MIXED USE RESIDENTIAL FLAT BUILDING
 256-258 Victoria Rd,
 Gladesville, NSW 2111

Drawing Title
**GENERAL ARRANGEMENT PLANS
 BASEMENT 1 & 2 GAP**

Project Number	Drawing Number	Revision
21-018	S4.55-101	B
Status	S4.55 APPLICATION

LEVEL 01

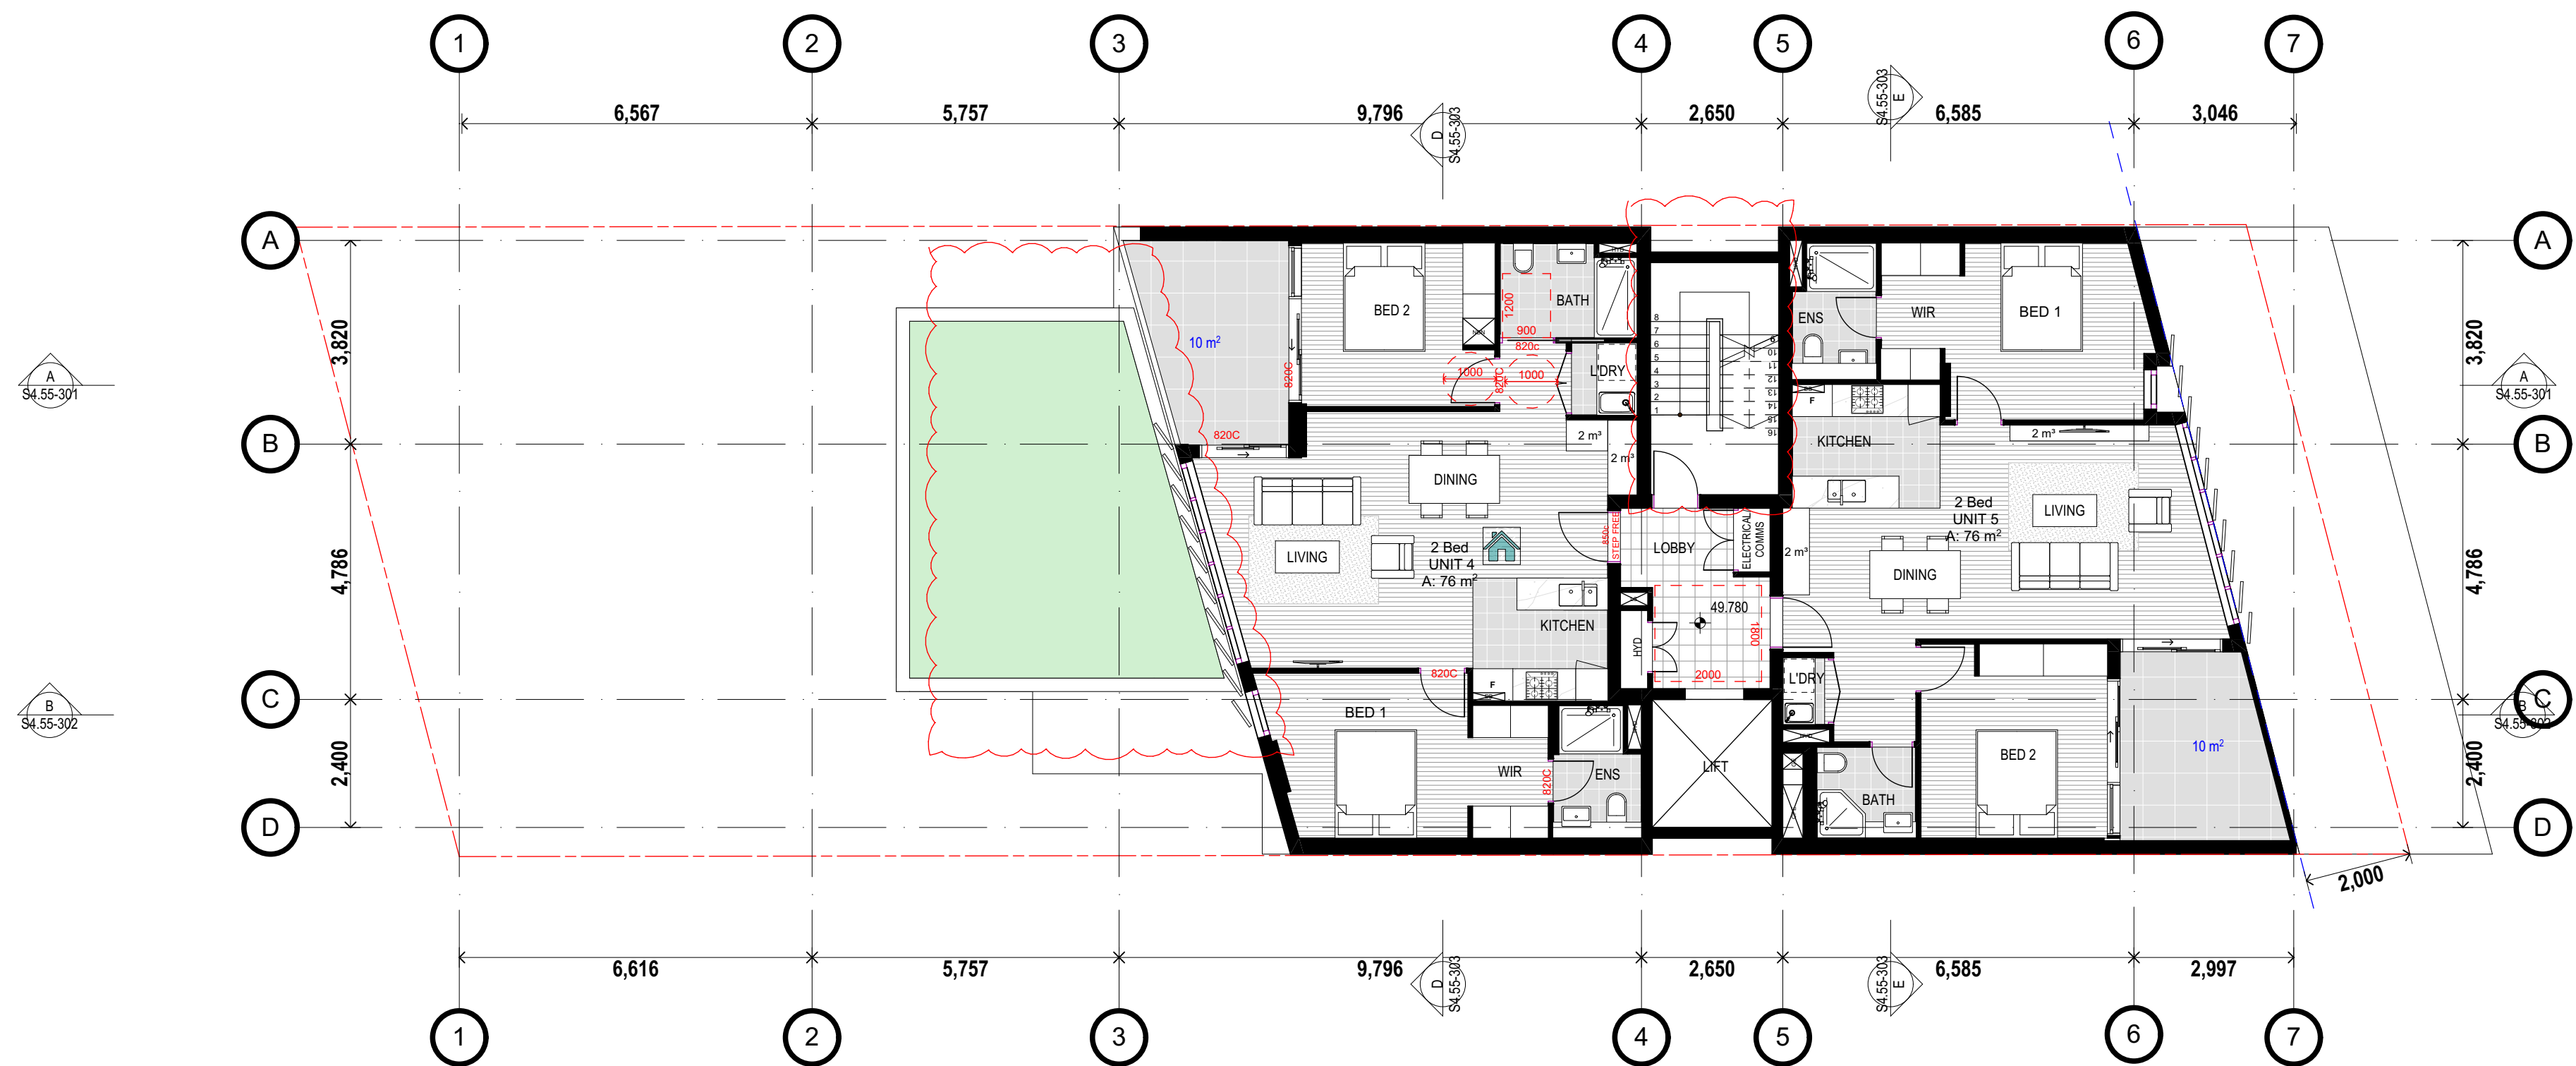
SCHEDULE OF AMENDMENTS
LEVEL 01:

- Landscaped roof minor layout amendment
- Fire stair enclosed

SCHEDULE OF AMENDMENTS
LEVEL 02:

- Fire stair enclosed
- Lobbies amended to allow for service cupboards

LEVEL 05

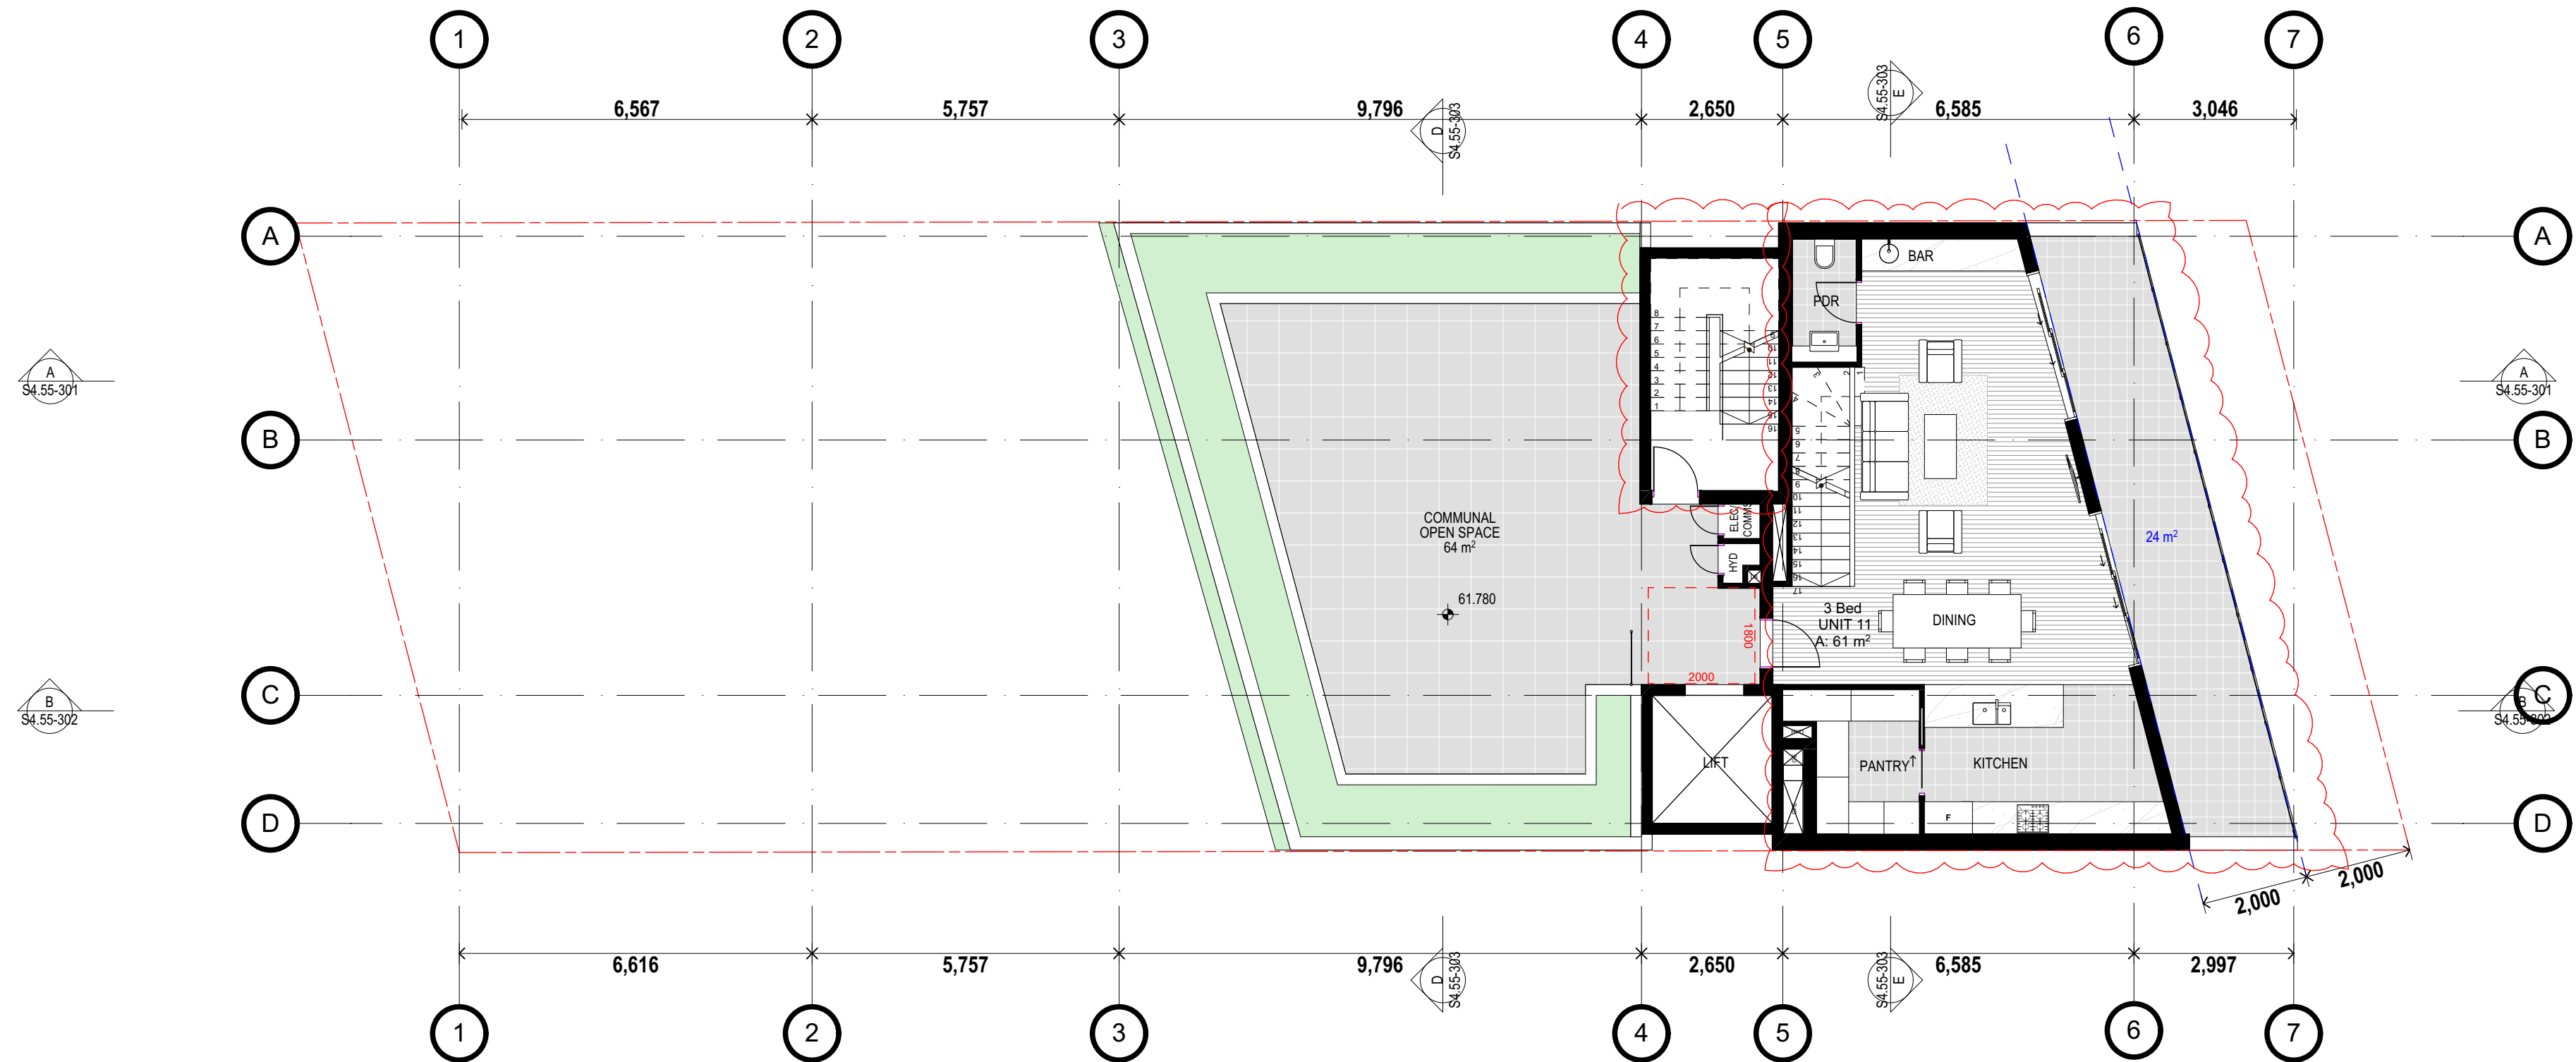
**SCHEDULE OF AMENDMENTS
LEVEL 05:**

- Fire stair enclosed
- Service cupboards added
- U-11 amended (reversed) - Bedrooms relocated to L4 with Liv./Kit./Din. added to L5

ROOF

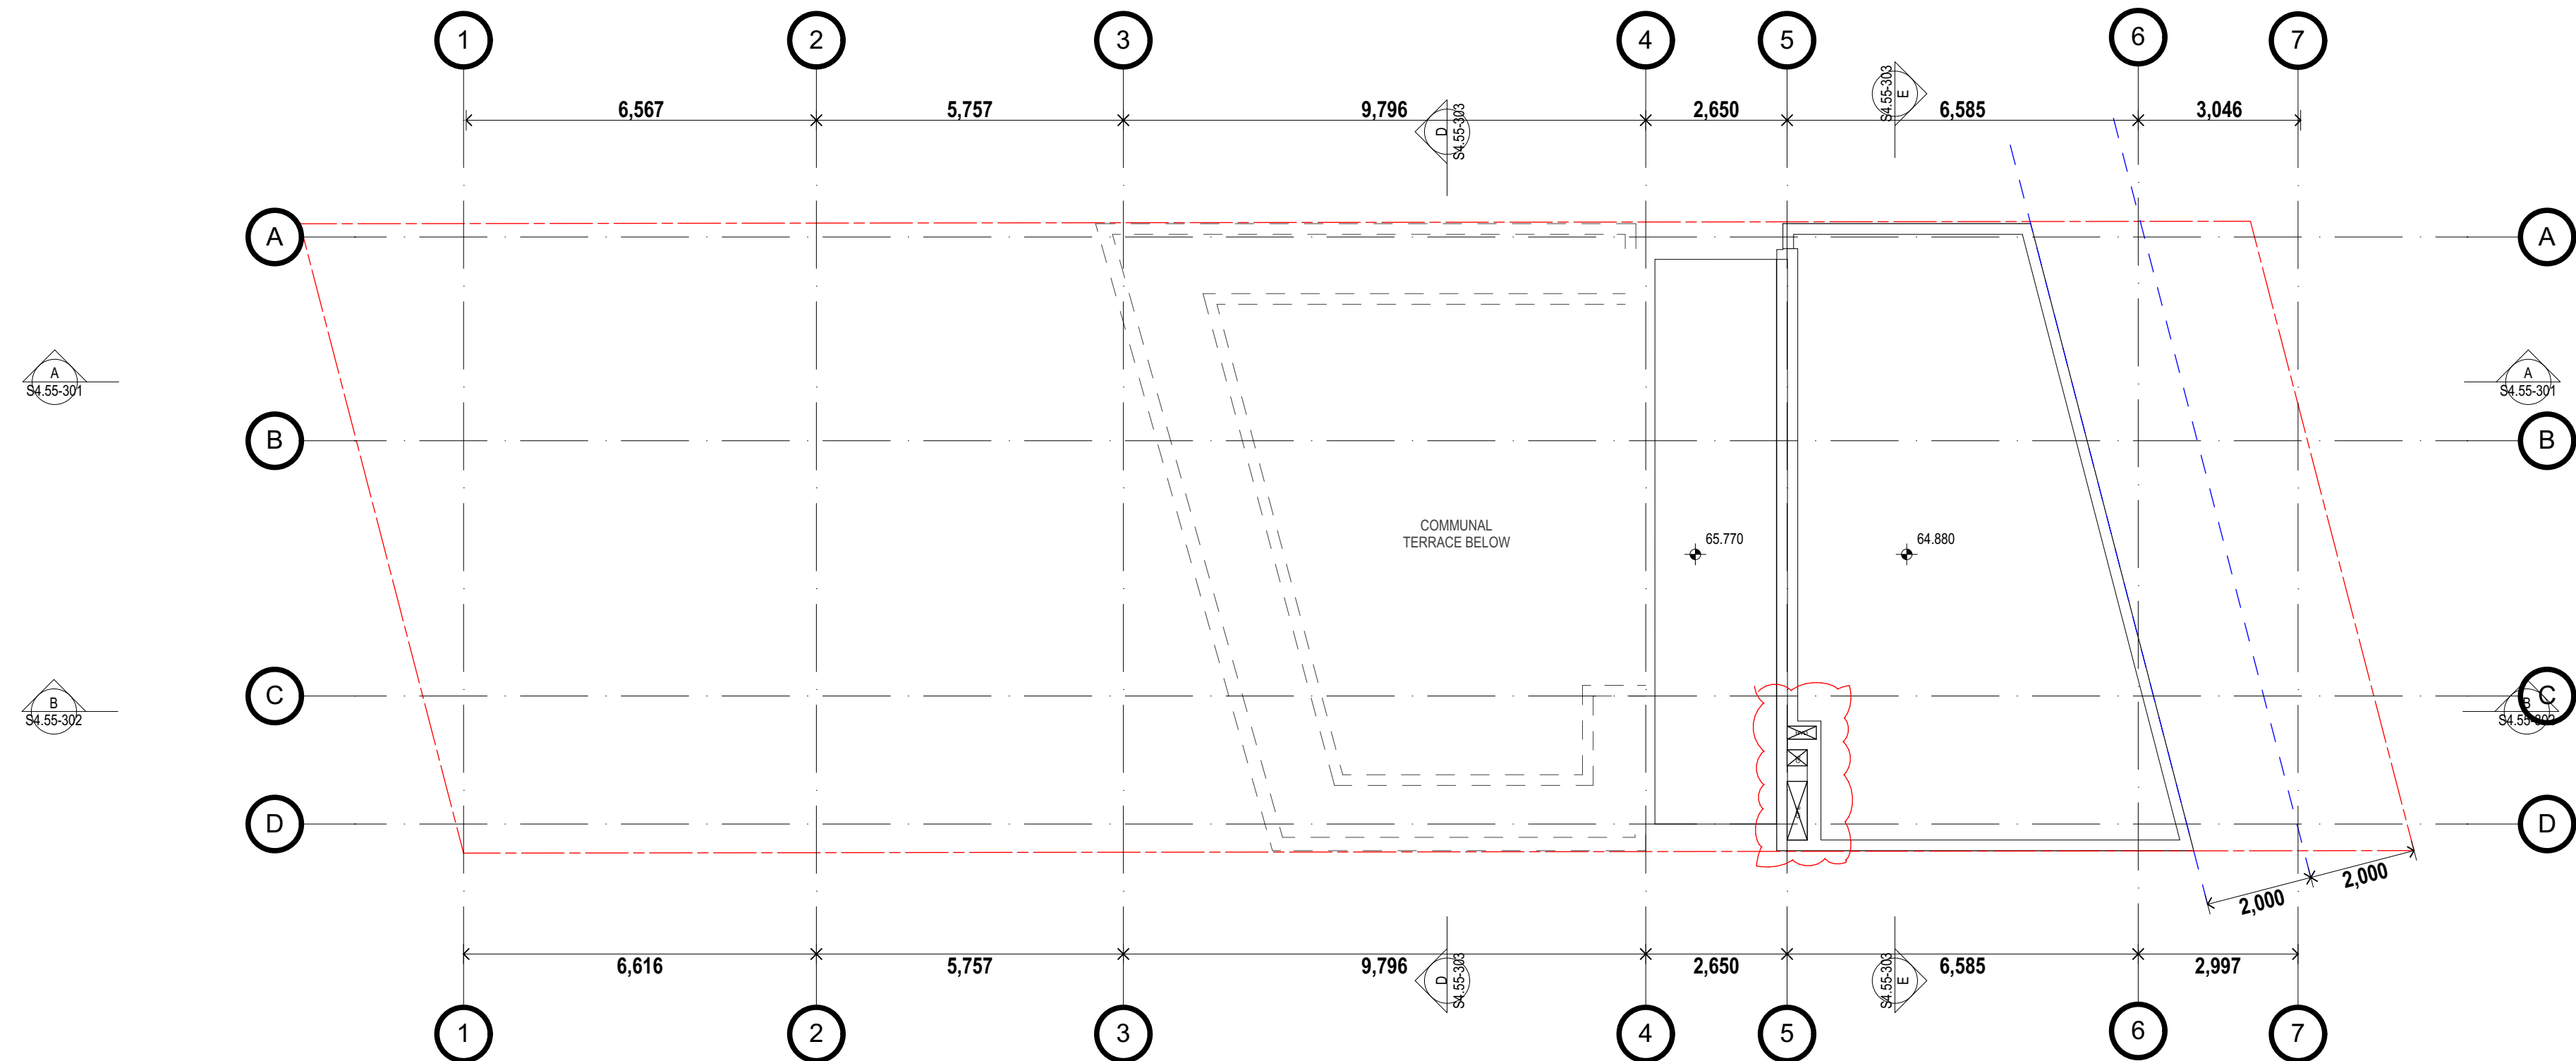
**SCHEDULE OF AMENDMENTS
ROOF:**

- Services added
